WILLIAMSON COUNTY, TEXAS

CHANGE ORDER NUMBER: 5

**Ronald Reagan Boulevard Widening
Williamson County Project No. 24IFB57**

Change Order No. 5

WILCO TEXAS	 an STV Company TEXAS REGISTERED ENGINEERING FIRM F-1741
RONALD REAGAN BLVD. SUMMARY OF ROADWAY ITEMS

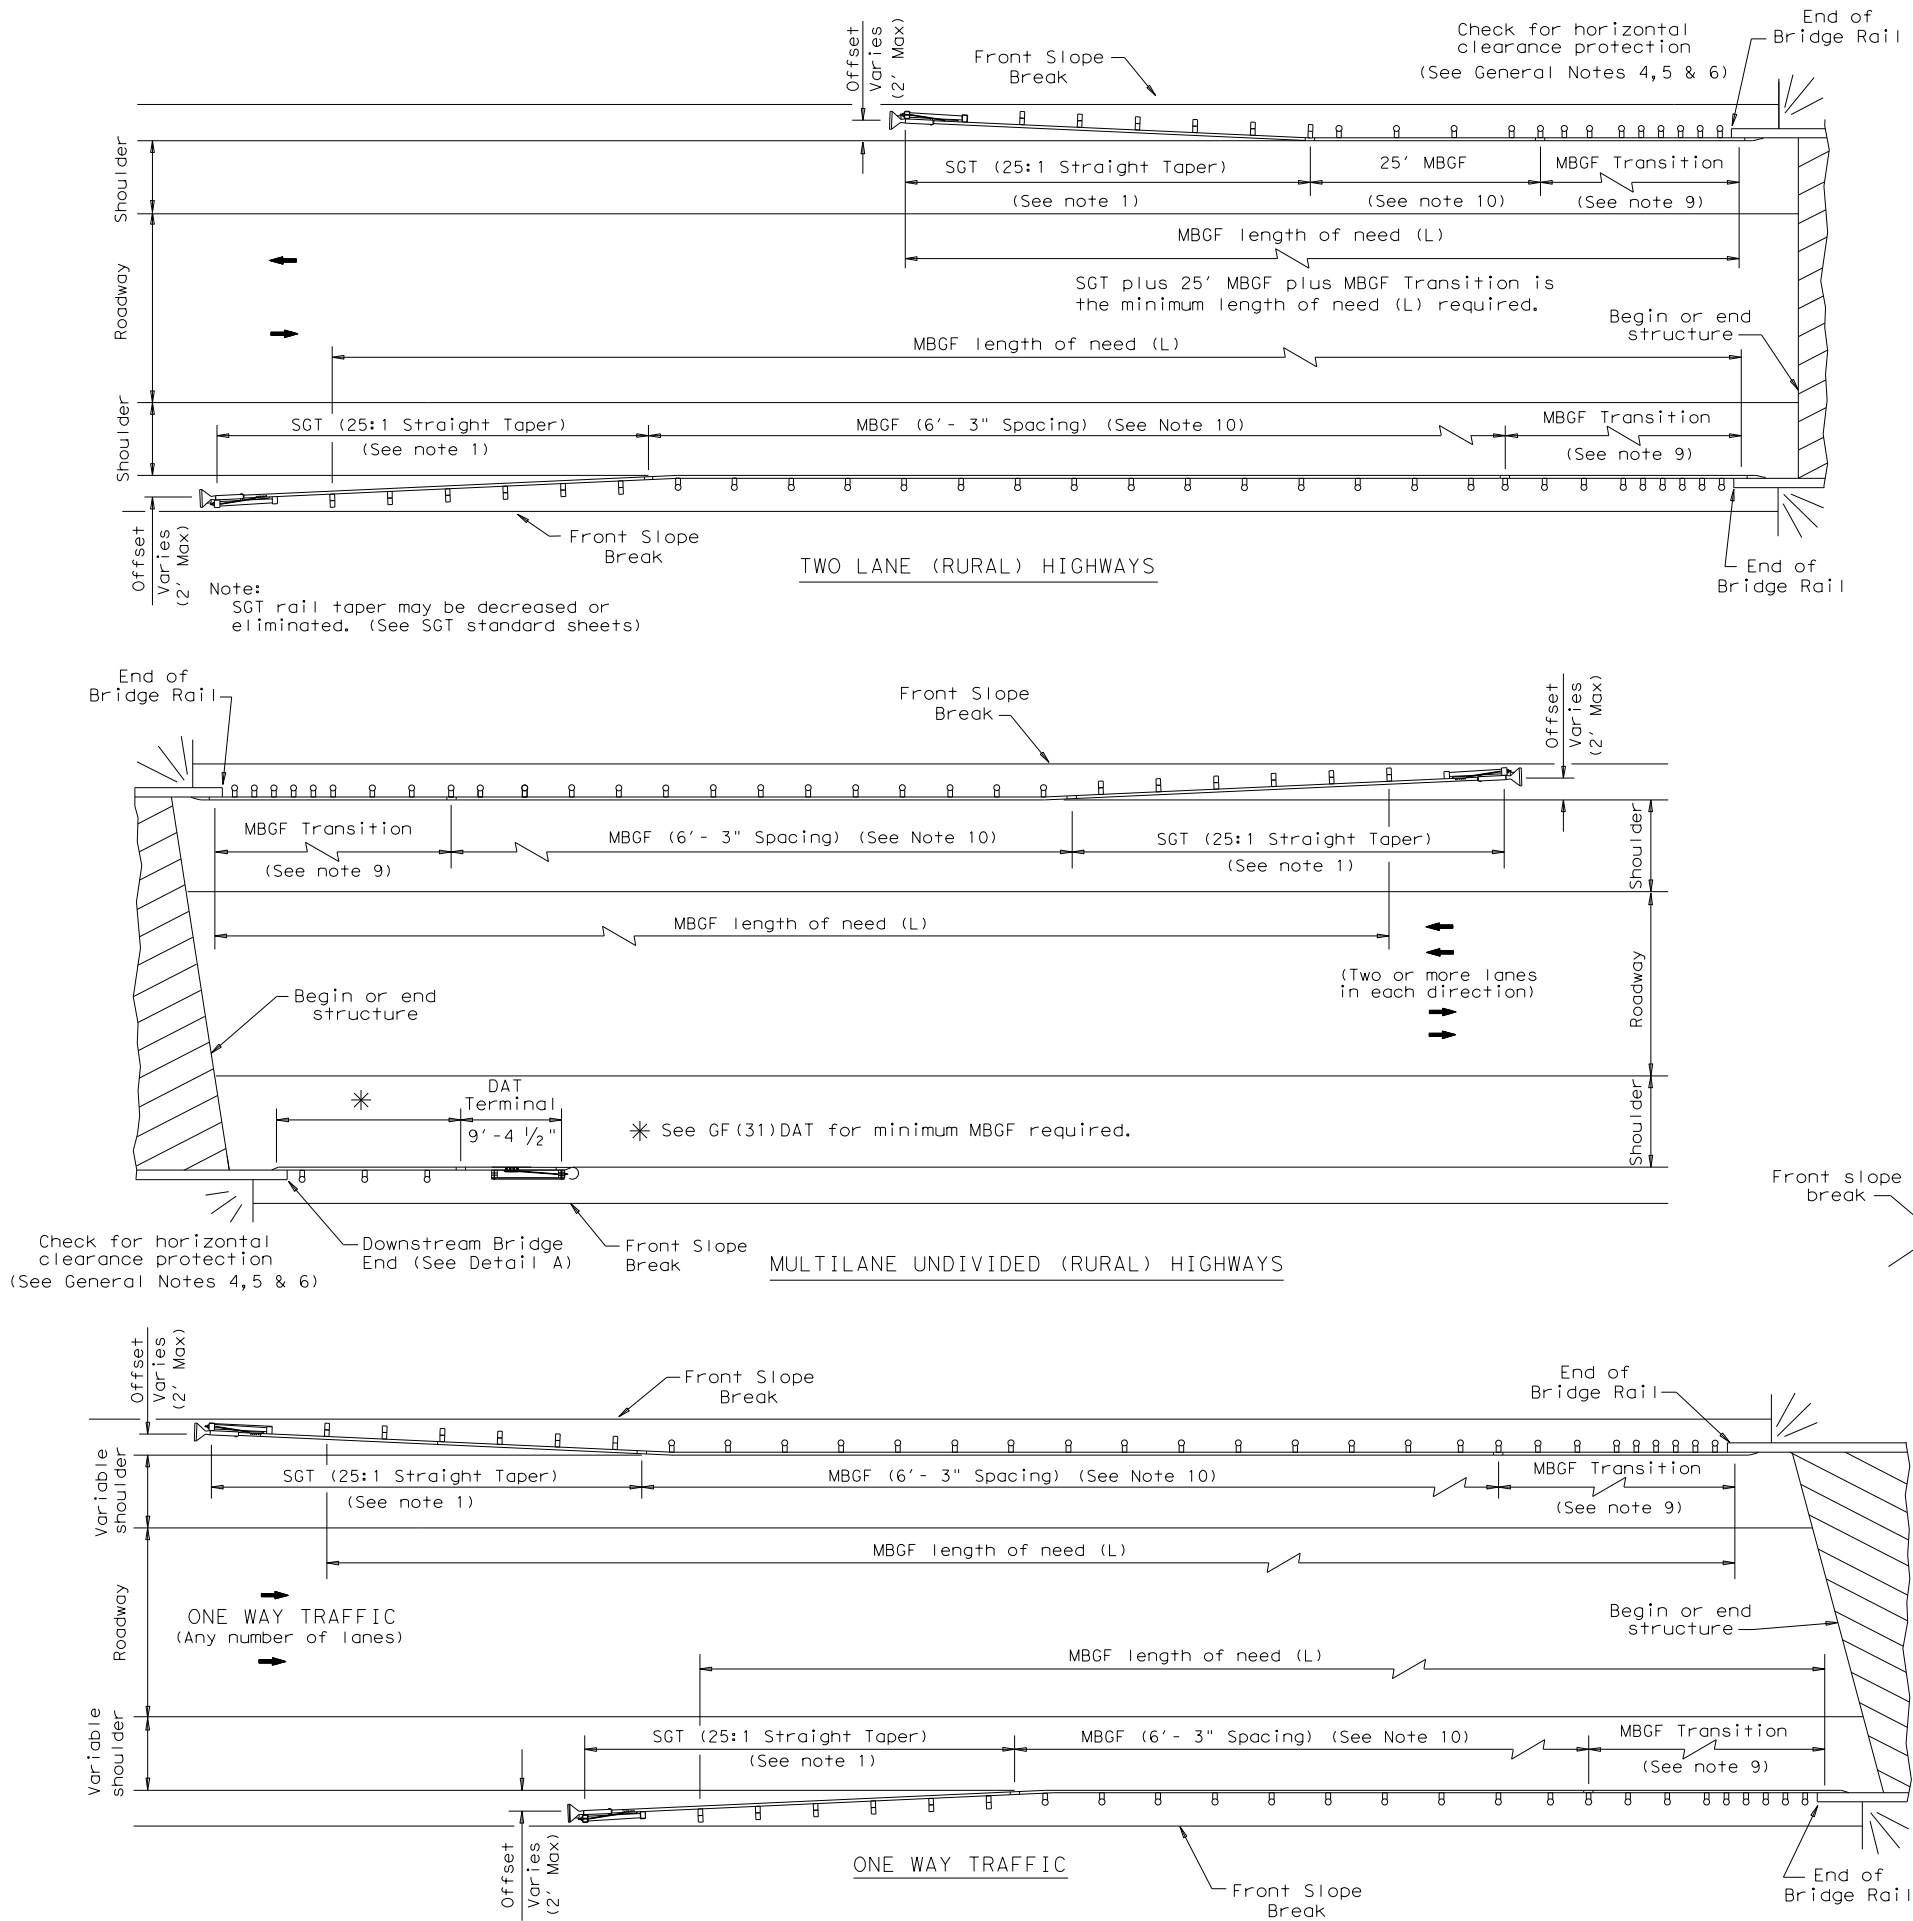
This Change Order adds an item for the transition sections of the metal beam guard fence (MBGF) to the concrete rail at all of the bridge locations. This item was left out of the plans and was discovered while reviewing RFI 44, which asks for clarification on the missing quantity between the C221 rail and the MBGF.

The C-221 rail stops at the SEJ at STA 2636+30. An additional 24.51' of C221 would be necessary to meet the MBGF. The distance from the missing rail plus thrie beam do not match to the MBGF ending at STA 2636+05.49 for both the left and right sides. Can we please get all stations verified for the MBGF and C221 rail on the North Fork San Gabriel River Bridge and revised sheets to reflect any changes.

C-221 rail begins at Sta 2636+12. "Begin bridge rail" label and dimension in the bridge layout (Sheet 424) has been updated. The original quantities and rail length have not changed. Connected to the bridge rail on both downstream sides is a MBGF Trans (Non-Sym), the details for which are shown on the BED-14 standard included in this package (sheet 214A). Item 540 6018 MBGF Trans (Non-Sym) has been included to match the plans. This has been updated in Sheet 21.
